CORPORATION OF THE CITY OF
CLARENCE-ROCKLAND

COMMITTEE OF ADJUSTMENT

May 21, 2020, 7:00 pm

Subject: Hydrogeological Assessment – Response to Review Comments
Proposed Land Severance – B-CR-006-2018 & B-CR-007-2018
3383 Old Highway 17 – Unit 11, City of Clarence-Rockland

Figure 1: Stations reviewed for identifying periods of seasonal low water conditions.

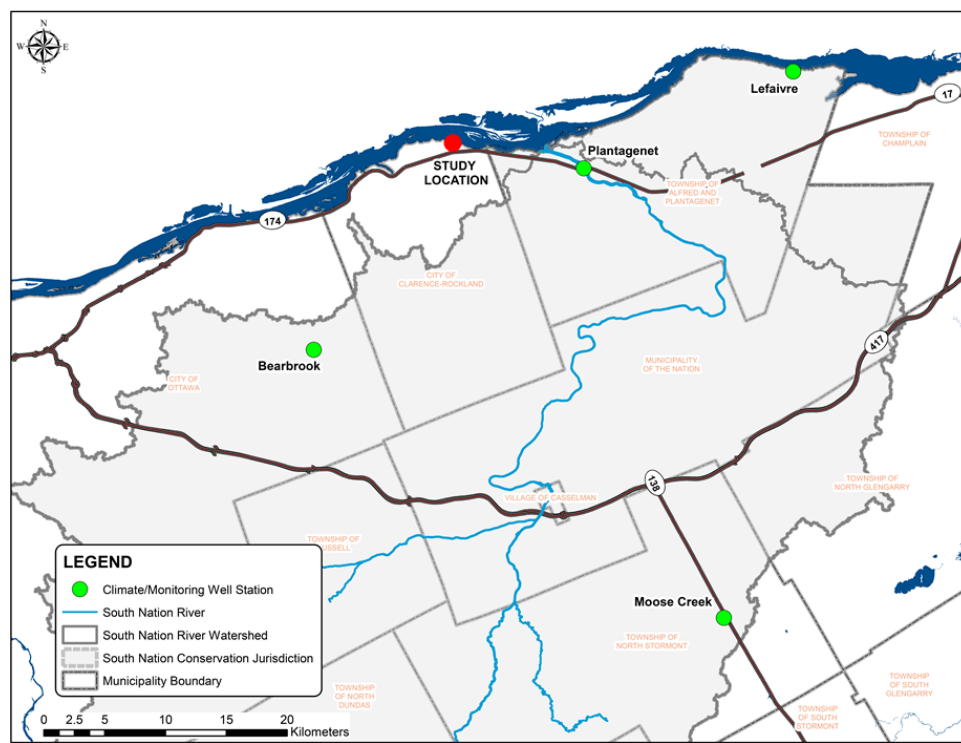
A pumping test was completed on August 12, 2019 at the new shallow dug well during a **time of seasonal low groundwater level**. Based on a review of the historical weather data and regional climate/monitoring stations for the date in question (Figure 1), August 12, 2019, would be reasonably considered a **period of seasonal low water** with respect to B-CR-006 (Figure 2).

Figure 2: Example of general watershed conditions through groundwater levels.

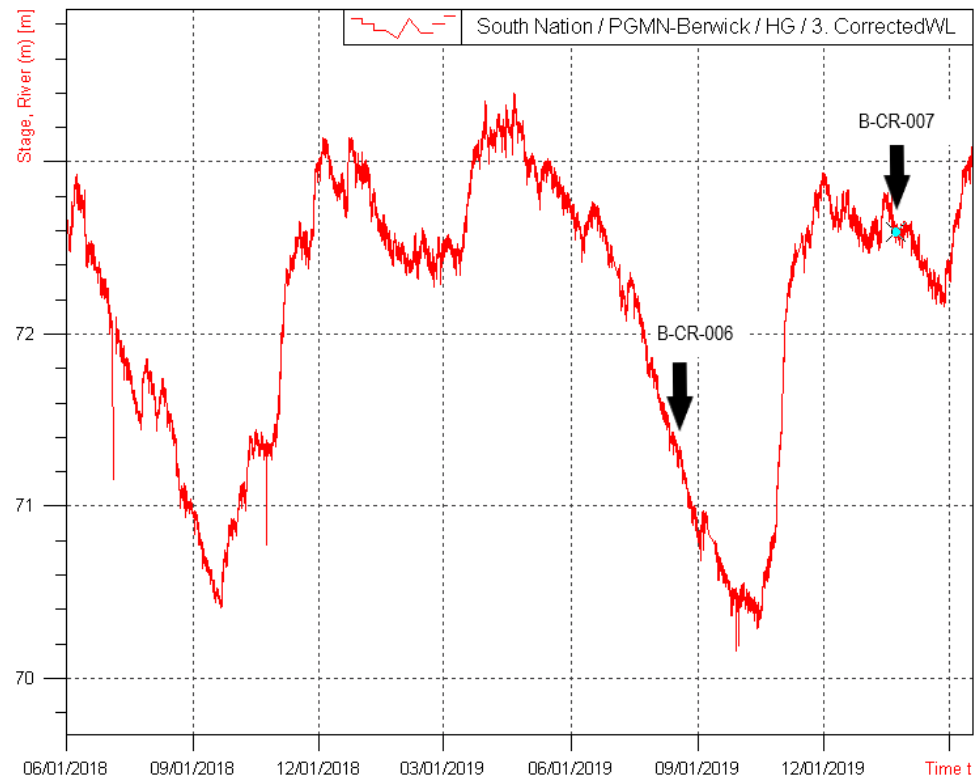
This statement is anecdotal and has not been demonstrated. Figure 2 shows that the watershed was not in a period of seasonally low water during this time. A significant melt and rainfall event, which equates to recharge, occurred on January 10 and 11 2020 (Figure 3).

Figure 3: Plantagenet Stream Gauge Station

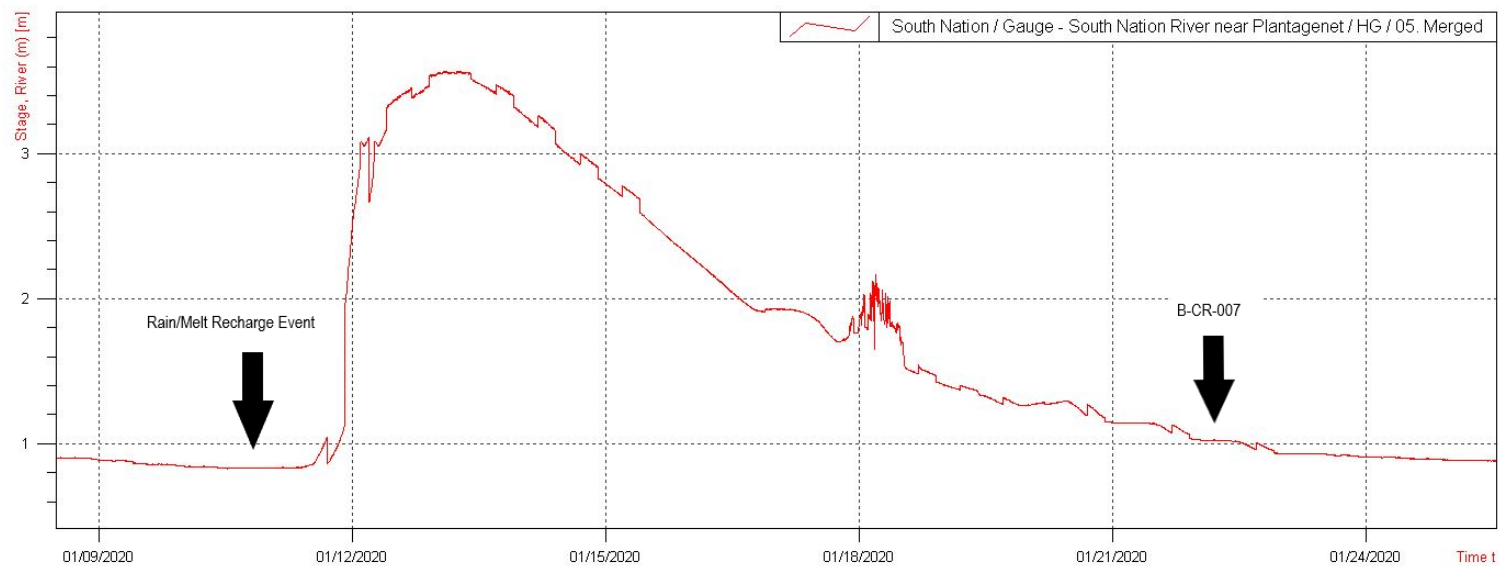
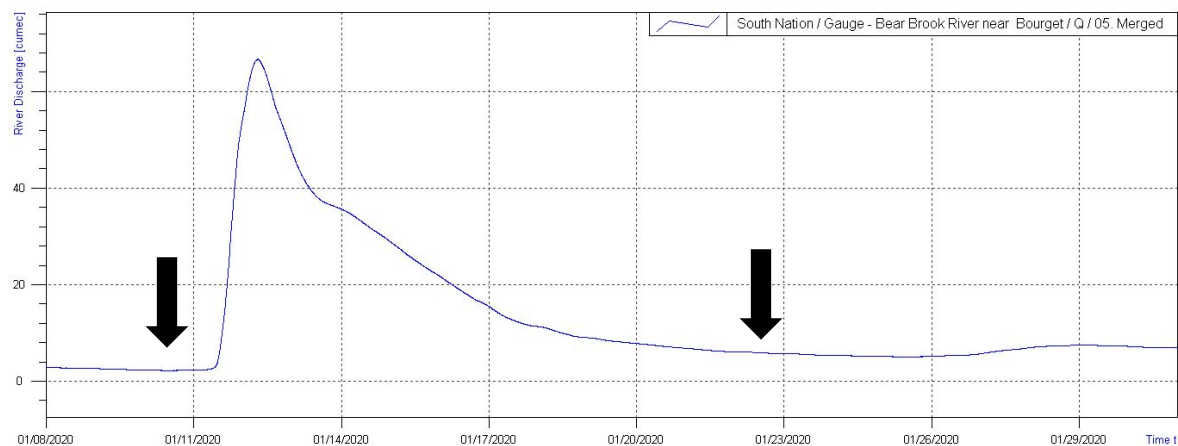
This event led to a significant increase in stream flow at the Bear Brook and Plantagenet stream flow stations (Figure 4 and Figure 5).

Based on a review of the available data, this pumping test was completed in a period where the pumping test would provide positive results. The pumping test indicates that over a 6-hour period almost the entire well reserve was removed; if the pumping continued longer the well would have gone dry.

Figure 6: Drawdown response for both wells.

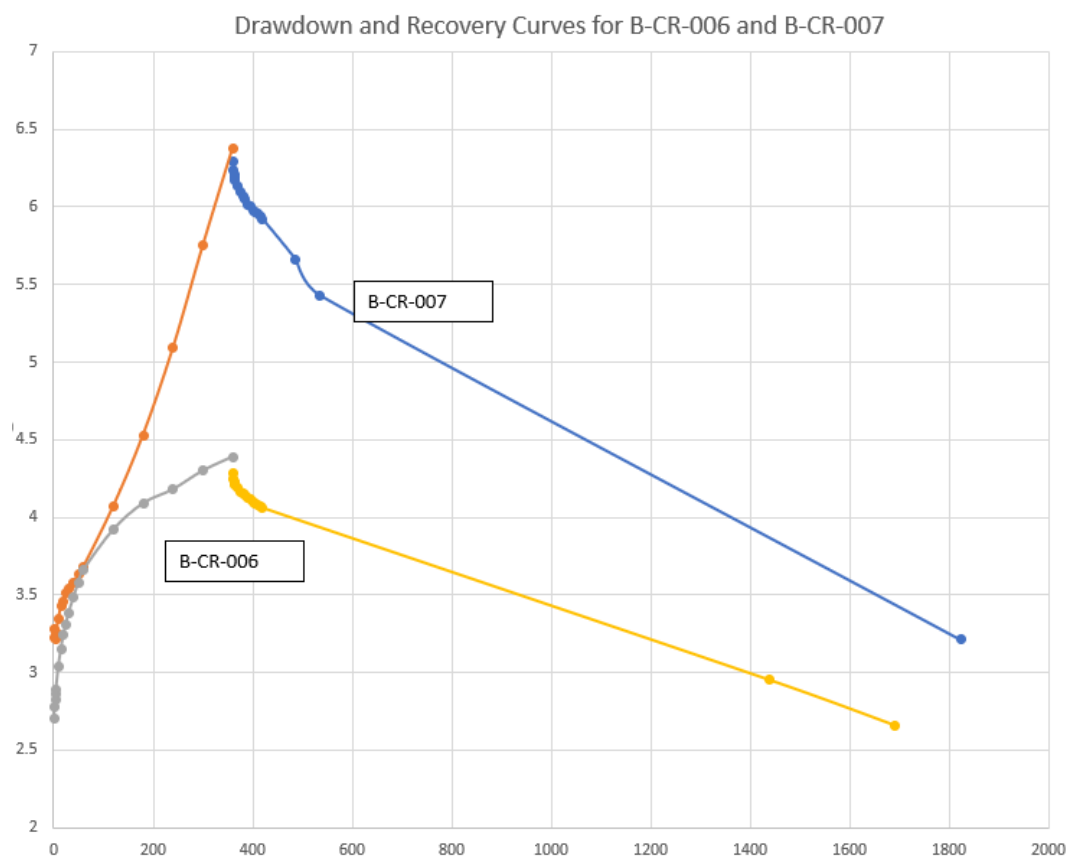
This behaviour is clearly shown by the almost linear response to drawdown (Figure 6). This figure shows how different both B-CR-006 and B-CR-007 are with respect to the aquifers targeted for potable water supply which also supports SNCs original concerns.

In order to meet the guidelines and demonstrate the well can serve a residential development, a pumping test must be **conducted during a time of seasonal low groundwater level**. The current pumping test for B-CR-007 was not completed as discussed. It is expected that under the required conditions, the well will not meet the guidelines.

We also note that the recovery curve is highly irregular for B-CR-007. Based on the geology and well construction, we are uncertain how the well could have recovered in a linear fashion. This does not match any example of confined or unconfined expected recovery curves. The pumping test should be completed similar to B-CR-006. Water level should be monitored continuously.
